Barangaroo

Part 3A Modification Report

HEADLAND PARK AND NORTHERN COVE

PREFERRED PROJECT REPORT

Figure 2: Proposed amendment to concept design for Headland Park & Northern Cove

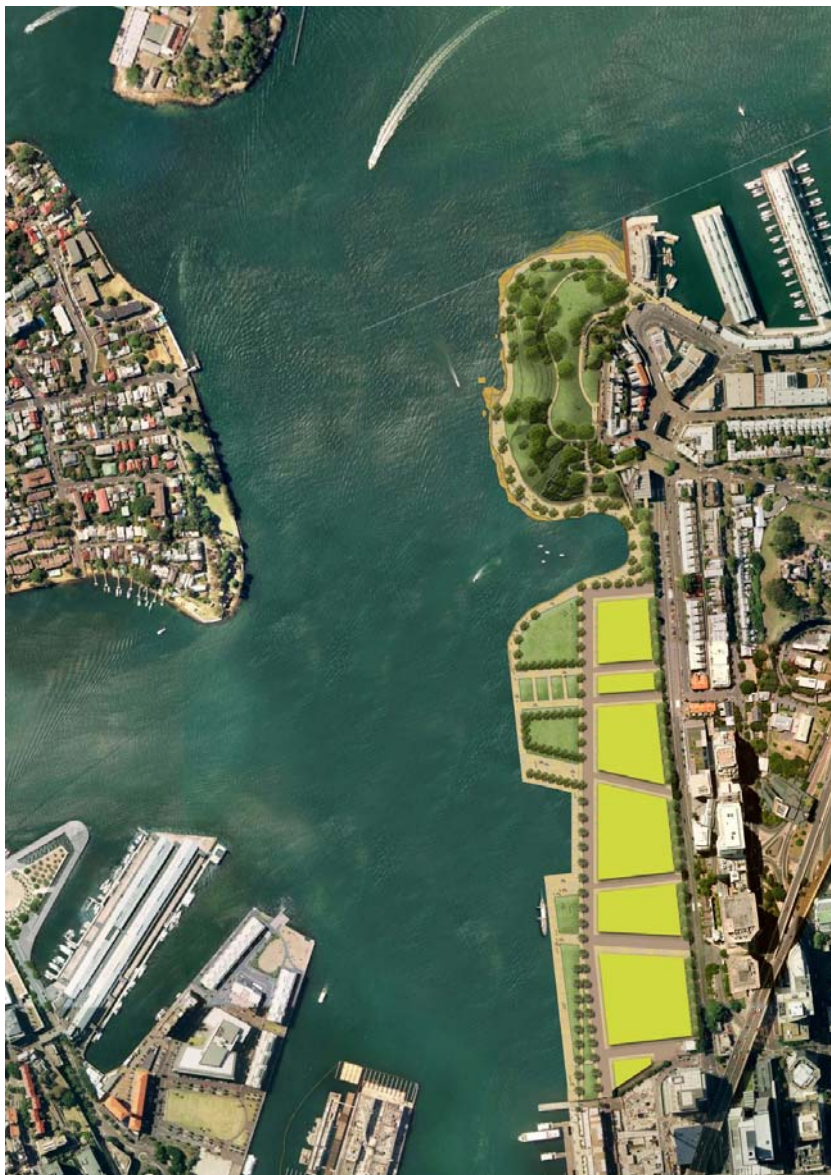
A number of submissions raised concerns in relation to the modified design of the headland. Concern was raised that the overall area of parkland on the headland will be reduced in comparison to the original proposal designed by Hill Thalys and that the reduction in the open space area to the south to accommodate the

Both Hill Thalys Architects and the National Trust raised concerns relating to the overall Headland Park design, stating that it is inconsistent with other headlands on Sydney Harbour. It is contended that the proposed design of the northern cove bears no resemblance to previous water bodies and will isolate the headland from the remainder of Barangaroo, effectively severing the foreshore park into two. The City of Sydney also expressed concern that the design of the northern cove has resulted in a “pinch point” at the southern side of the northern cove (near the proposed return of Globe Street) and does not provide a wide enough area to allow for free flowing pedestrian movement between the headland and the south of Barangaroo.

However, it is acknowledged that the headland configuration proposed in the exhibited S75W Modification Report suggested a more stylised and simplified representation of the landform than would be the case with a natural headland. To achieve a more naturalised shape and form as required by the Minister's Terms of Approval, an amended design is now proposed as shown below in Figures 2 and 3 and in the plans at Appendix 3. This amended design provides for a more natural profile, with a series of rock shelves and rocky outcrops similar to other major headlands within Sydney Harbour.

The modified design has been based on further analysis of the 1836 shoreline by the Design Excellence Review Panel, the urban design consultants and the Authority. Through the study of early plans and images, a more detailed understanding of the profile size, location and topography of the 1836 shoreline has emerged. Both the Design Excellence Review Panel and the Authority are of the view that this amended design displays a greater integrity and authenticity than the exhibited design. At the same time, the proposed design of the Headland

The area of public open space (land component) in the amended design is comparable to that in the approved plan (approximately 5.2ha as compared to 5.1ha in the approved plan).
